Zoning Board of Appeals Regular Meeting
Wednesday, June 24, 2026, at 7:00 PM
Simsbury Town Hall – Main Meeting Room
933 Hopmeadow Street, Simsbury CT, 06070

STAFF REPORT MEMORANDUM

RE: **Application ZBA #26-09** of Jared and Jessica Rosenblatt, Owner, for a ± 27 sq.ft. variance from Section 3.9 of the Simsbury Zoning Regulations to reduce the front yard setback from 50' to 23' and a variance from Section 3.5 of the Simsbury Zoning Regulations to allow an accessory structure in the front yard at 24 Fox Den Road (Assessor's Map Block Lot D10 147 101) Zone R-40.

RE: **Application ZBA #26-10** Sunny Yum, Owner, Residential Resorts LLC, Applicant, for a ± 15' variance from Section 3.9 of the Simsbury Zoning Regulations to reduce the side yard setback from 40' to 25' to install an 18' x 36' pool at 54 Old Stone Crossing (Assessor's Map Block Lot A18 503 023B) Zone R-40.

Figure 1 Proposed Site Plan

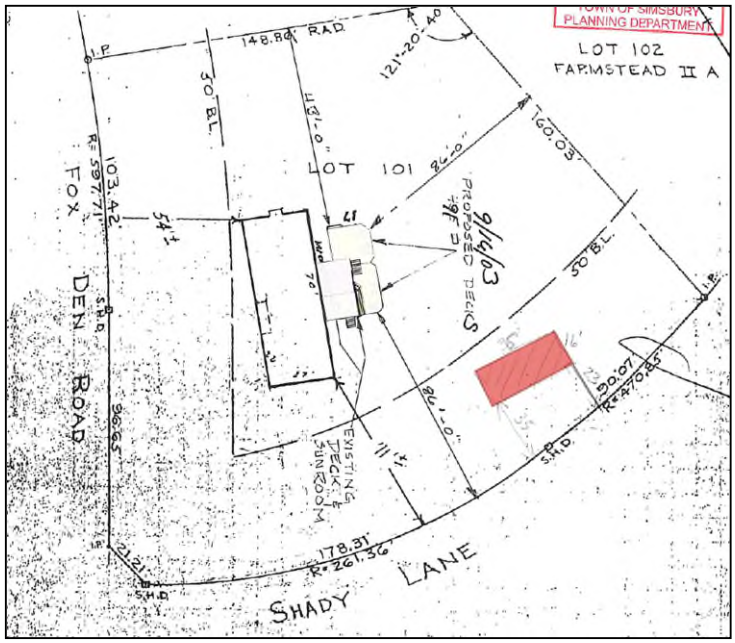
The applicant is requesting a ± 27-foot variance to install a 576 sq.ft. shed in the front yard of the home at 24 Fox Den Road. The regulations require the shed to be no closer to the road than the house on the lot while meeting the 50' front yard setback. However, due to difficult topography and corner lot restrictions the applicants are applying for a variance for the proposed location. While the size and height of the shed meet the requirements under the regulations, the location requires a variance to allow the shed in the front yard and a 27-foot variance to reduce the front yard setback.

The applicant is stating placing the shed in the allowed buildable area according to the regulations would require the need to install retaining walls and supporting landscaping.

Staff Finding: More information is needed to determine how the financial impact of complying with the regulations constitutes a legal hardship.

Figure 1 Proposed Site Plan

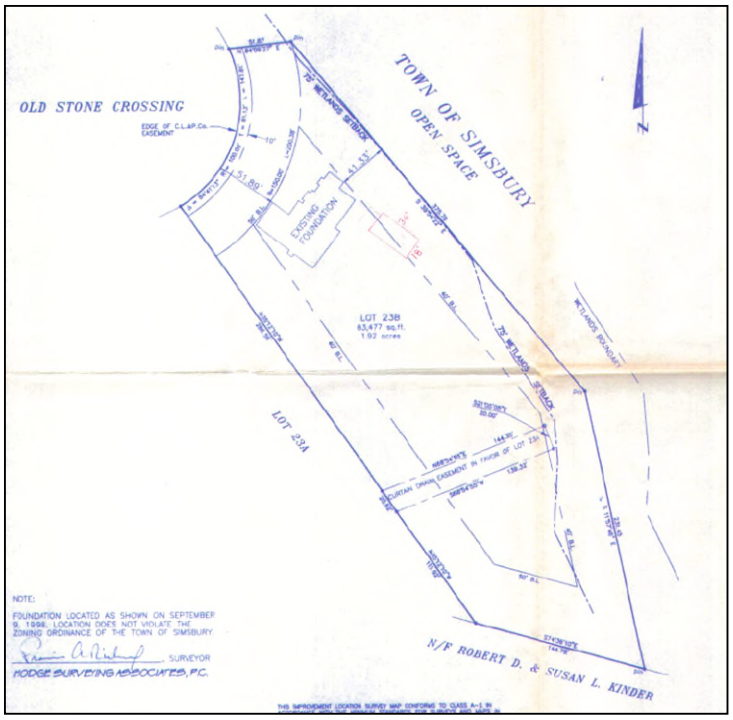
The applicant is requesting a ± 15-foot variance to install a 36' x 18' pool in the side yard setback at 54 Old Stone Crossing. The regulations require the pool to be no closer than 40' from the side property line. However, due to the size of the lot shape, orientation of the home on the lot, and the septic and drainage systems on the lot, the applicant is applying for a variance for the proposed pool location. While there are no regulations related to the size or shape of the pool, the placement near the side property line requires a variance.

The applicant claims the irregular lot shape and angled orientation of the home on the lot are unique factors that restrict development.

Staff Finding: The regulations require the pool to be 40' from the side property lines. The lot is 1.92 acres; however, the narrow shape reduces the buildable area on the sides of the home. These factors contribute to an extraordinary condition relative to the zoning district.

Figure 2 Septic System Map for Illustrative Purposes Only

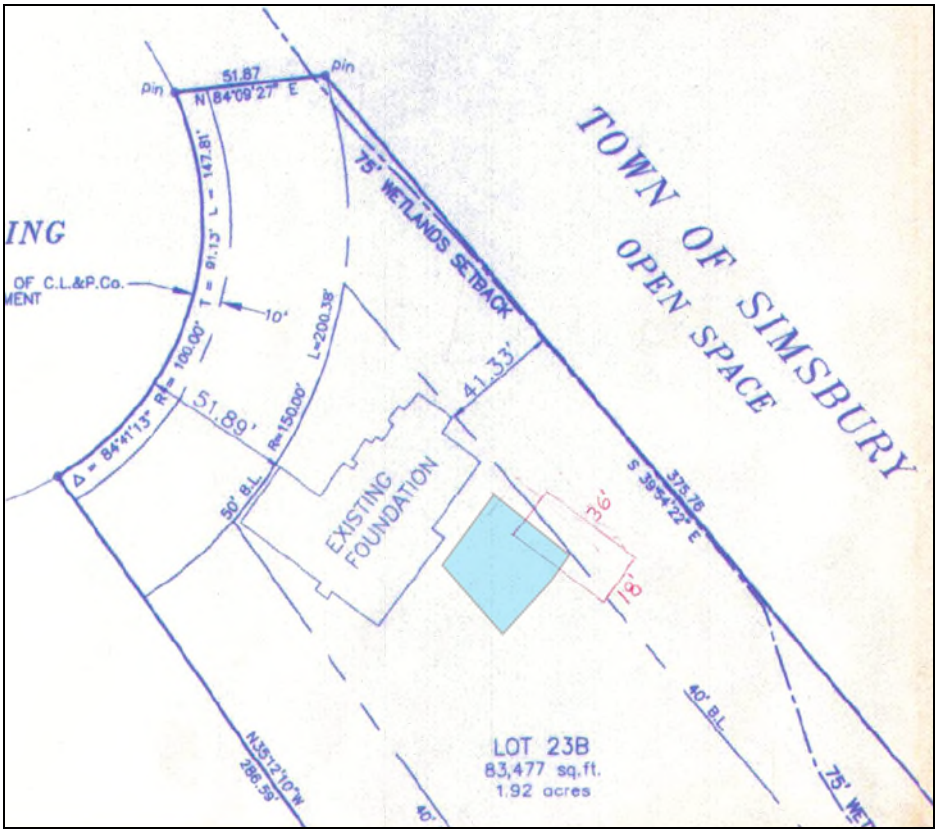
The applicant claims the existing septic system and curtain drain on the property further limits the feasible area for the pool installation.

Staff Finding: The approximate location of the septic system is shown in Figure 2. The septic footprint covers a substantial portion of the area off the rear of the home. The proposed location requires review by the Farmington Valley Health District. The curtain drain easement extends horizontally across the rear of the lot per Figure 1. The presence of the easement would impact potential options for the pool installation.

Figure 1 Proposed Sign Plan

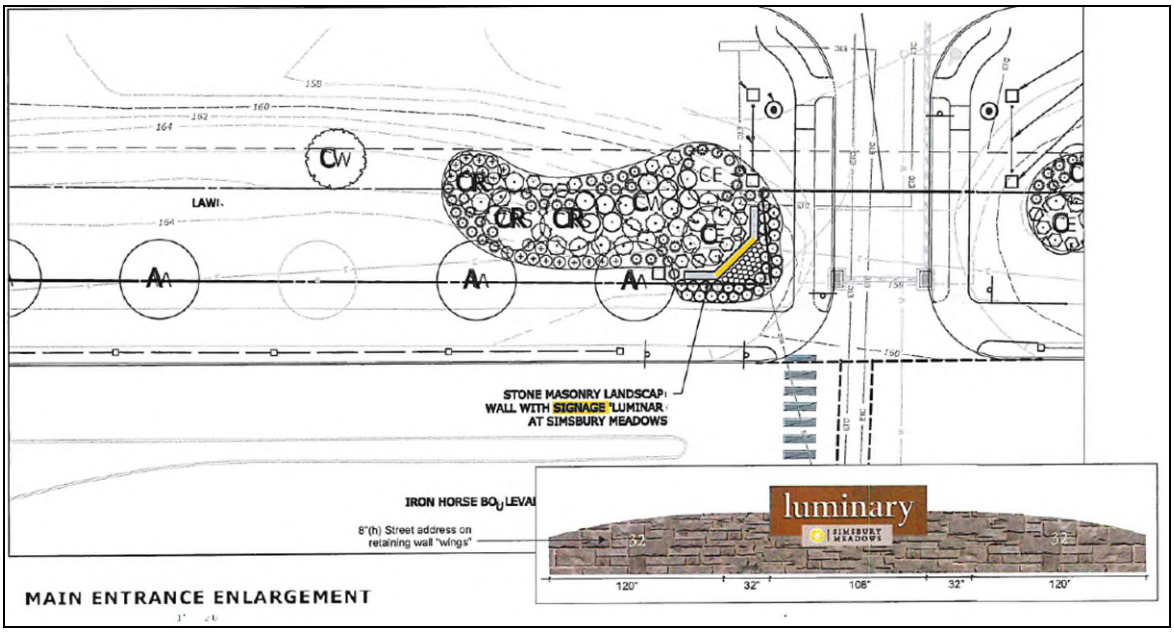
The applicant is requesting a ± 13 sq. ft. variance to install a 29 sq. ft. freestanding sign at the entrance to Luminary at 32-36 Iron Horse Blvd. The center zone regulations require all freestanding signs to be no larger than 16 sq. ft. However, due to the size of the parcel, scale of the development and the amount of frontage along Iron Horse the applicant is applying for a variance for the proposed sign size. While the location of the sign meets the requirements under the regulations, the increase in size requires a variance. The site plan is included on Page 2. An enlargement of the entrance sign design is below.

Figure 2 Site Plan

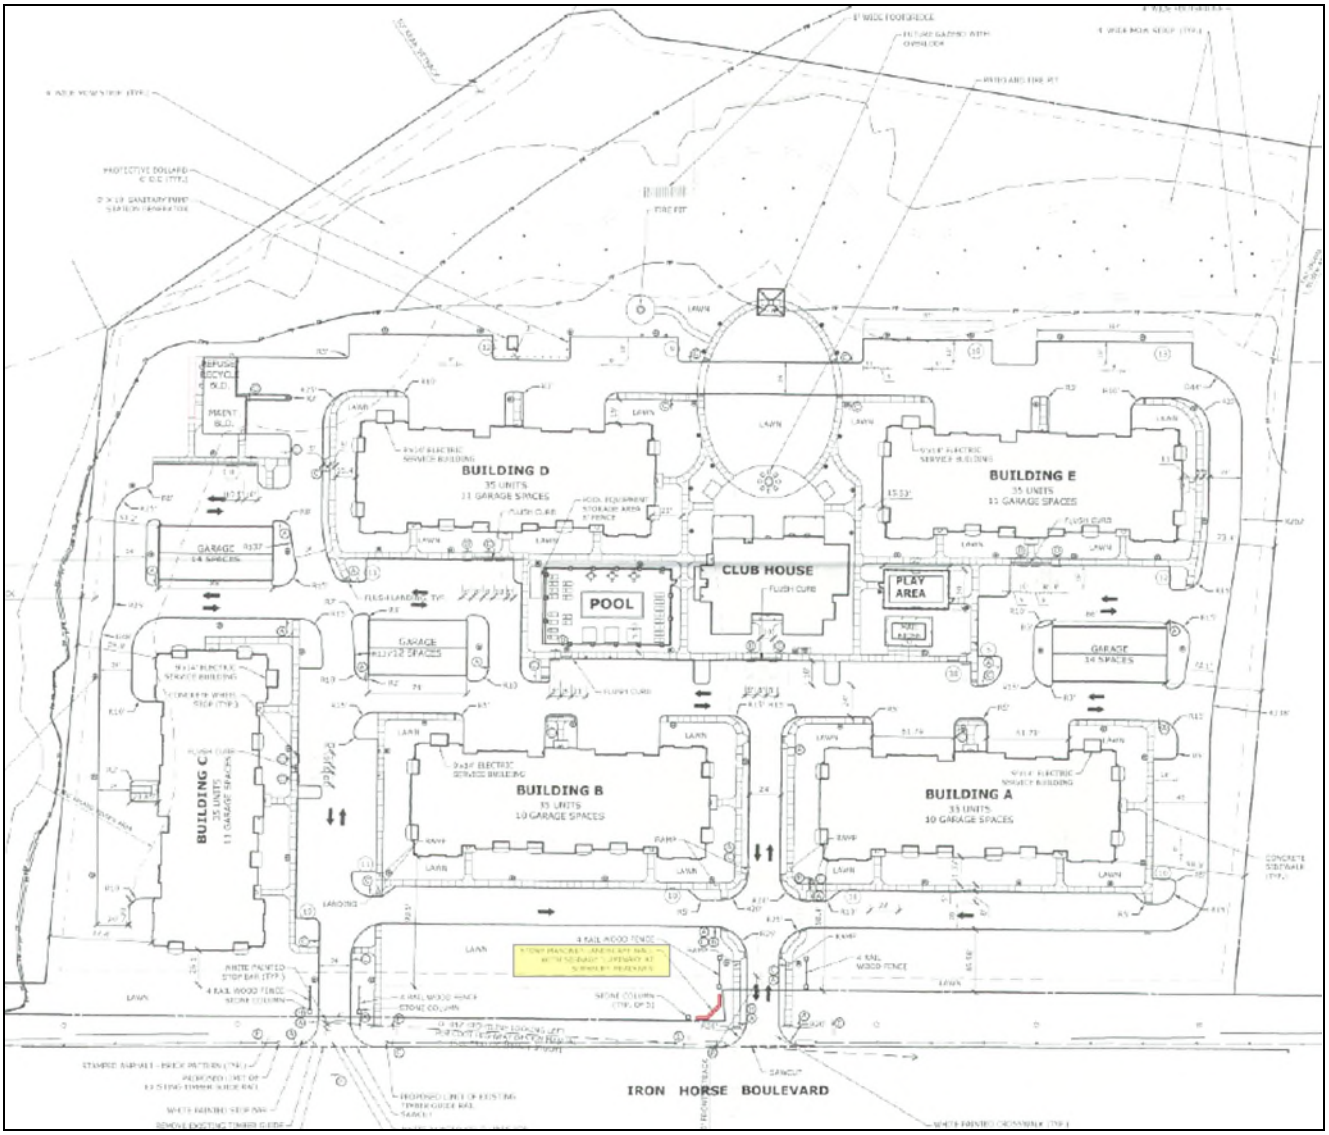
Staff Finding: The regulations limit freestanding signs in center zone to one square foot of sign area for every two linear feet of frontage, provided the maximum surface area does not exceed 16 sq. ft. The regulations also allow parcels with 300 feet or more of frontage to have two freestanding signs. The property includes 175 residential units on 13.85 acres and contains approximately 900 feet of frontage

along Iron Horse Blvd. These factors contribute to an extraordinary condition relative to the zoning district.
